寄件者: Yancy <[REDACTED]>
寄件日期: 2026年08月31日星期一 16:16
收件者: tpbpd/PLAND
副本: William Shu Tai WONG/PLAND; Adrian Tsz Hin TAM/PLAND; 'Cannis Lee'
主旨: RE: Planning Application No. A/NE-STK/36 --- Proposed Temporary Drone Training
Centre with Ancillary Facilities for a Period of 3 Years
附件: STK36_FI2_RtoC_submission_with coverletter.pdf
類別: Internet Email

Application for Planning Permission for Proposed Temporary Drone Training Centre with Ancillary Facilities for a Period of 3 Years at Lots 1368(Part), 1369, 1371, 1372, 1373, 1376, 1377, 1378(Part), 1379, 1381, 1382, 1383, 1384, 1385, 1392, 1393, 1394, 1395, 1396, 1397, 1398(Part), 1399(Part), 1400(Part), 1401, 1402(Part), 1403 and 1404 in D.D. 41 and Adjoining Government Land, Tong To Ping Tsuen, Sha Tau Kok, N.T.
(Application No. A/NE-STK/36)

Table 1: Responses to Comments from Government Departments and the Public on Planning Application No. A/NE-STK/36 (31.8.2026)

Figure 4A

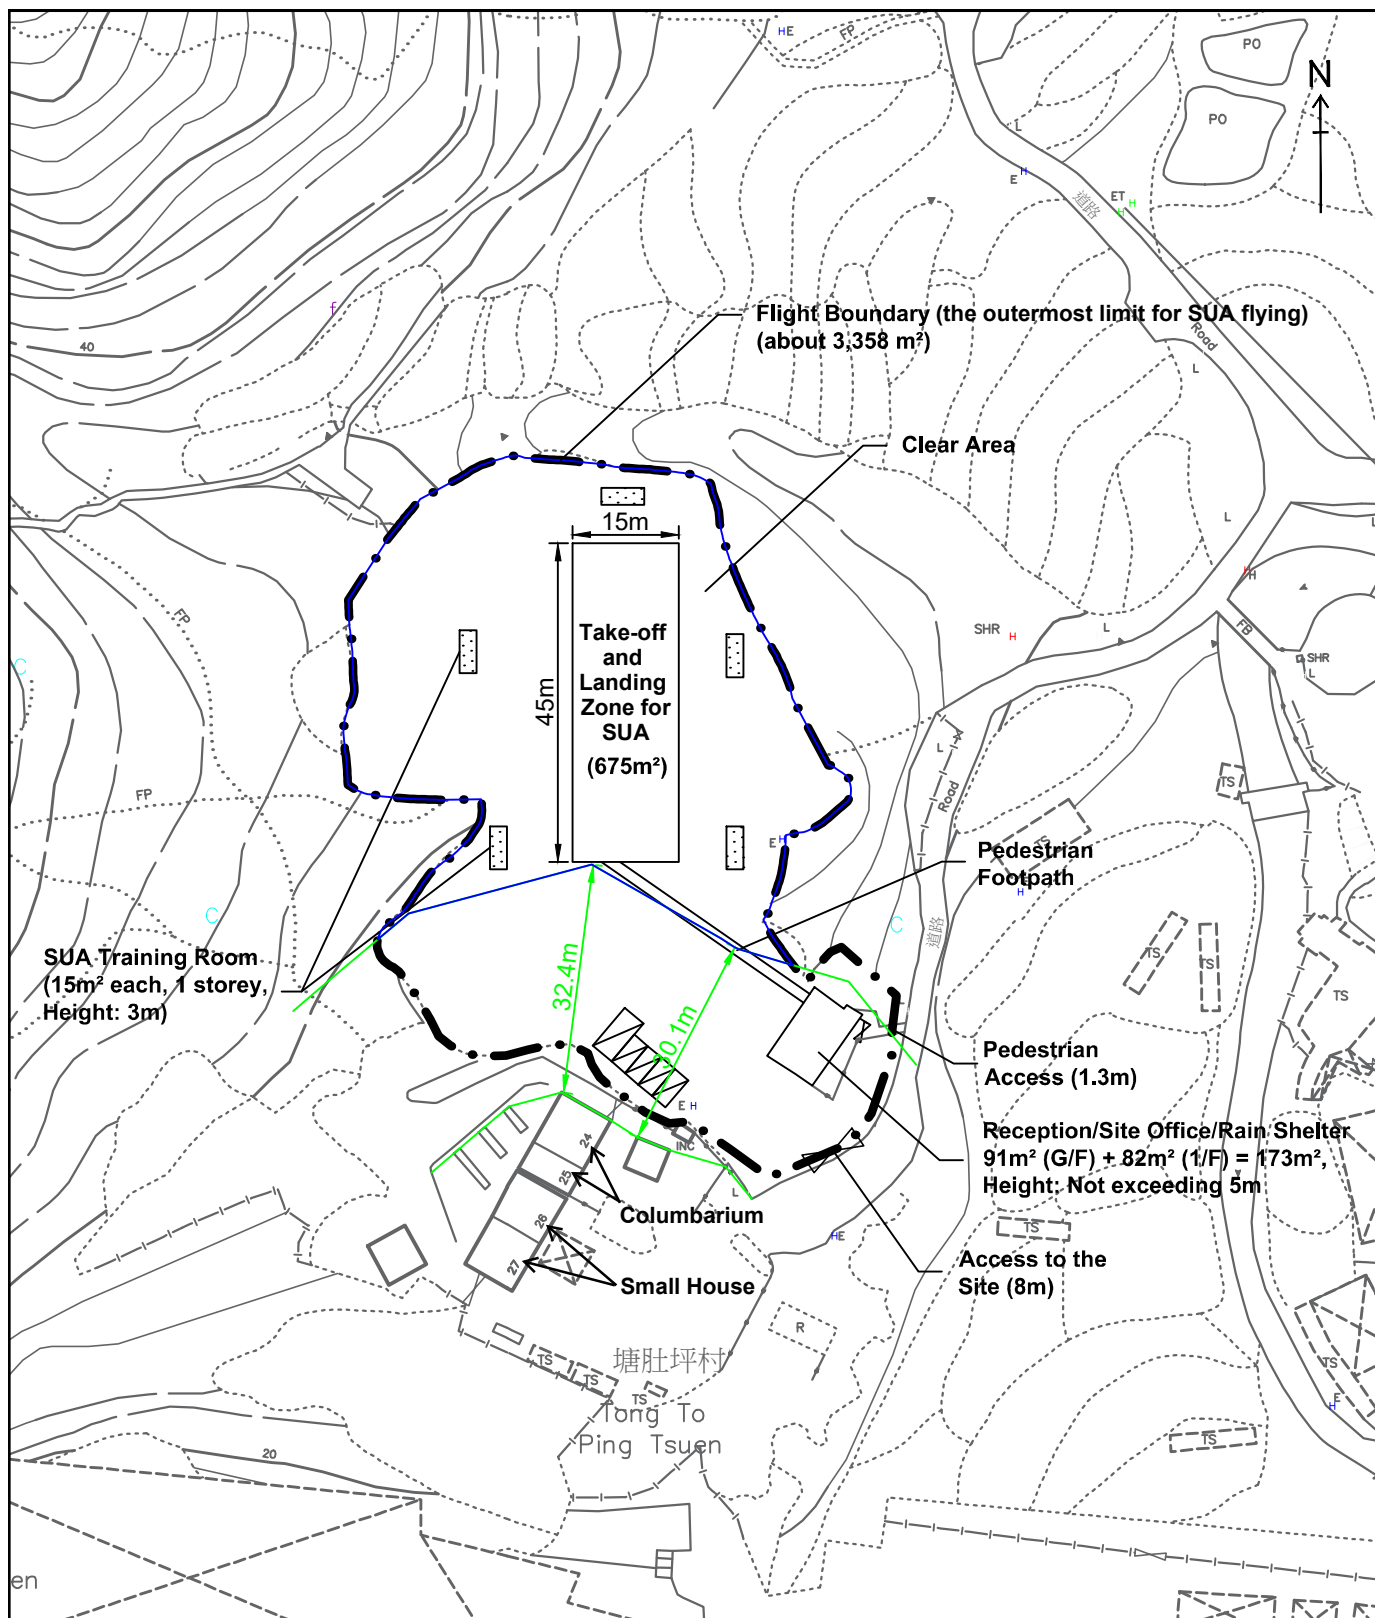
2. Transport Department (TD)	
(a) It is noted that there is over 2m level different between the ingress/egress point and the formation level of application site. The applicant should provide a proposal on the vehicular access arrangement for the ingress and egress routes leading to and from the application site.	(a) The 2.0m level difference will be overcome by a graded ramp with cut-and-fill without requiring excessive land or major roadworks. The driveway will rise gradually with a maximum 1:10 gradient, which is within the acceptable limit for private cars and 16-seat minibuses. A speed signage of 5km/h will be placed at the entry point to slow vehicles before they access the site. The proposed access arrangement

COMMENTS	RESPONSES
	is technically feasible, safe, and compliant for private cars and a 16-seat minibus.
3. Civil Aviation Department (CAD)	
(a) For the minimum lateral separation, the site for SUA training, in general, should be well separated and cordoned from uninvolved people, structures, vehicles or vessels and not located within Restricted Flying Zone (RFZ). When determining the distance to be maintained between the SUA and students / staff, an SUA operator and/or SUA ATO should take into account the instruction / safety guidelines issued by the SUA manufacturer, size and safety features of the SUA, and the applicable operating requirements. The distance between a Category A1 SUA and any person who is not involved in the flight operations, or any vehicle, vessel or structure that is not under the control of the remote pilot, measured horizontally and at any altitude, shall not be less than 10 m. The distance between a Category A2 SUA and any person who is not involved in the flight operations, or any vehicle, vessel or structure that is not under the control of the remote pilot, measured horizontally and at any altitude, shall not be less than 10 m (with the flying speed of the SUA not exceeding 20 km/hr) or not less than 30 m (with the flying speed of the SUA exceeding 20 km/hr but not exceeding 50 km/hr).	(a) The Application Site is not located within a Restricted Flying Zone (RFZ). The Applicant will strictly adhere to the instructions / safety guidelines issued by the SUA manufacturer, size and safety features of the SUA, and the applicable operating requirements. The SUA's flying speed will not exceed 50 km/hr. Please note that the flight boundary will be set back 30m distance (for Category A2 and C SUAs) between a SUA and any person who is not involved in the flight operations (i.e. the approved columbarium and nearby small houses) (see the revised Layout Plan at Figure 4A). Therefore, the operational flying area will not exceed this flight boundary (i.e. the outermost limit the SUA is permitted to fly), thus ensuring compliance with the separation requirement.

(b) Clarification on the flying range of drones	(b) Drone take-off and landing will be strictly confined to the designated take-off and landing zone in the middle of the Application Site, as shown in Figure 4A . The flying area will not extend beyond the flight boundary. The operation of the proposed development will adhere to the regulatory and operating requirements set out in the Safety Requirement Document prepared by the Civil Aviation Department.

(g) Please advise the use(s) of the five "SUA Training Rooms" indicated of the layout plan.	(g) The training rooms are used for briefings and the practical training of and ground control of SUAs.

We refer to the departmental and public comments regarding the captioned application. Our consolidated responses are set out in **Table 1** enclosed herewith for your consideration. In addition, the Layout Plan has been revised (see **Figure 4A**). Please note that the Take-off and Landing Zone refers to the designated area for take-off and landing of SUAs, while the Flight Boundary refers to the outermost limit the SUA is permitted to fly.

TITLE : LV CABLE LAYING &
POLE STAY ERECTION &
OHL & POLE REMOVAL AT
TONG TO PING TSUEN

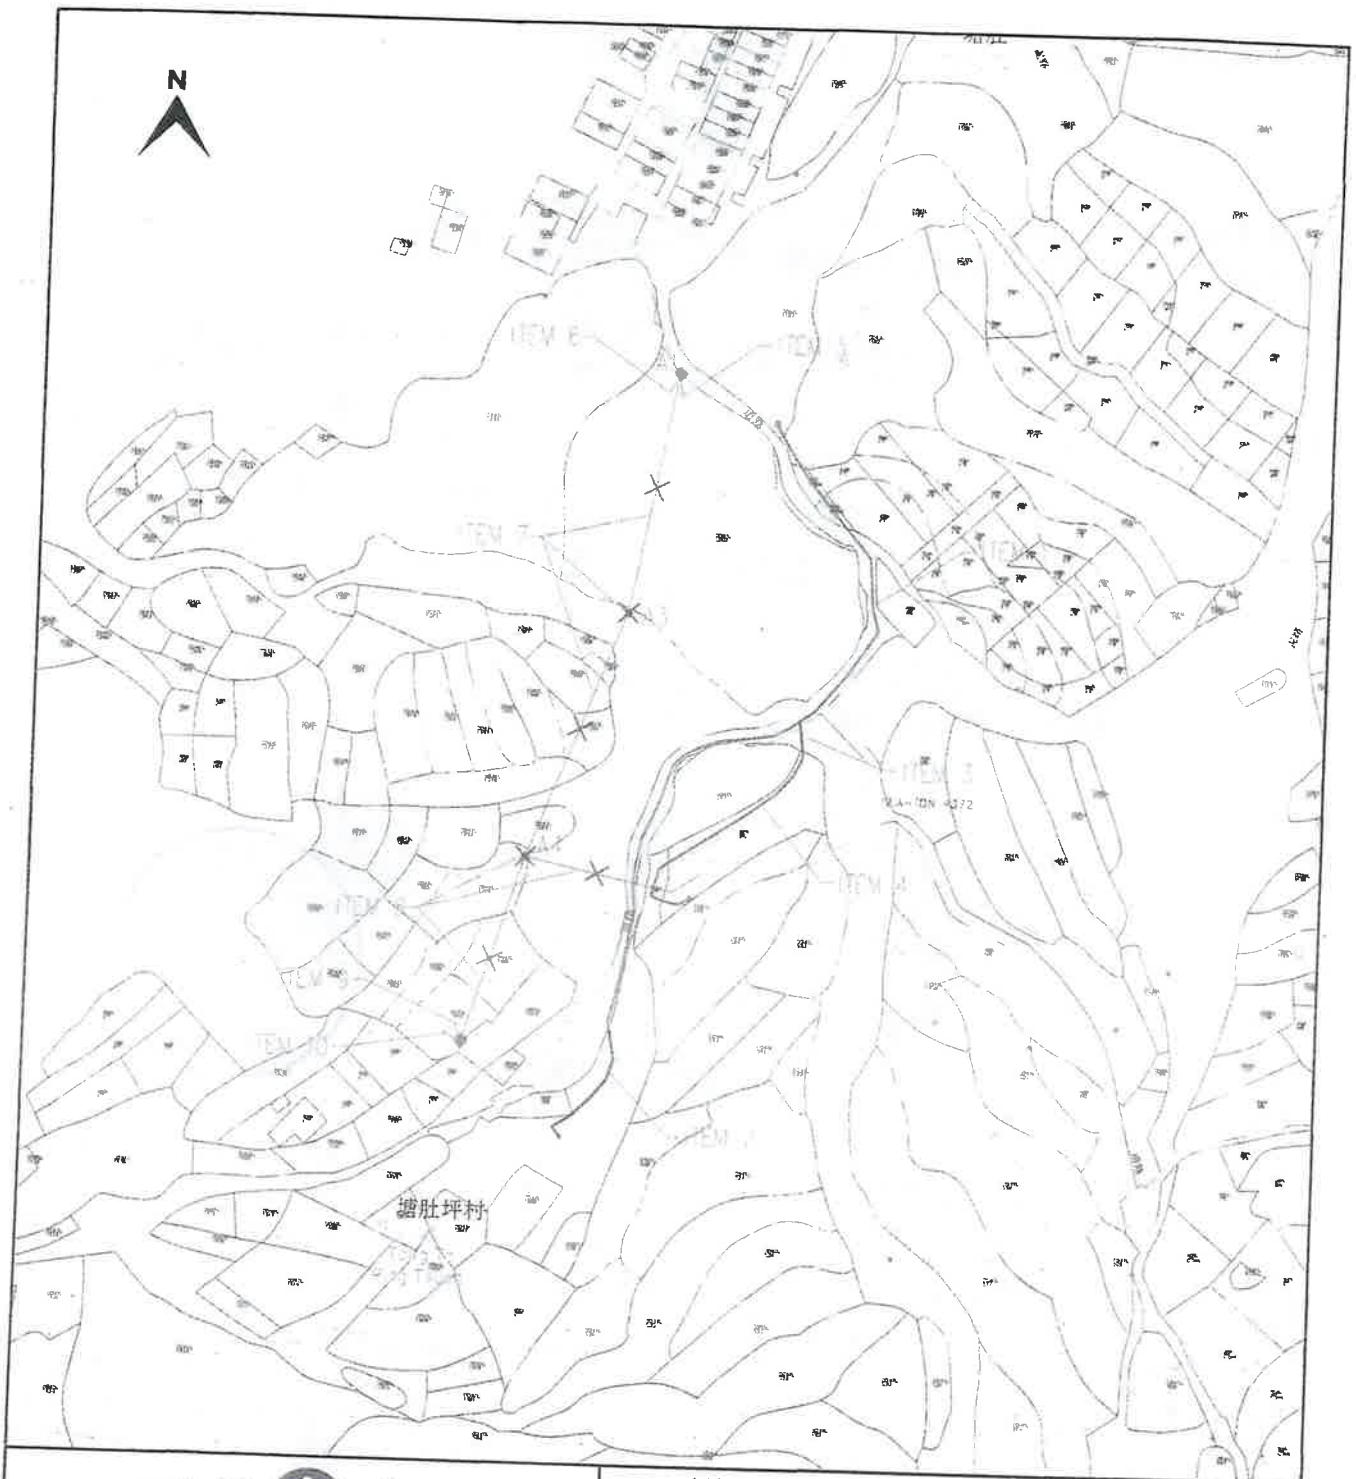
COMMENTS	RESPONSES
(e) There are two electric poles with overhead powerlines within the Site. Please clarify.	(e) The two electric poles with overhead powerlines within the Application Site will be relocated (see Annex 1 for documents relating to the relocation of power lines). The application for relocation has been submitted and is currently under processing.

Notice is hereby given that CLP Power Hong Kong Limited has applied to the District Lands Office / North for LV Cable Laying & Pole Stay Erection & OHL & Pole Removal works on the Government Land near Tong To Village in D.D.41 (as shown on the attached plan). Any objections should be lodged in writing with the District Lands Officer / North within 14 days from the date of this notice (Address: 6/F., North District Government Offices, 3 Pik Fung Road, Fanling, New Territories). No late objections will be considered.
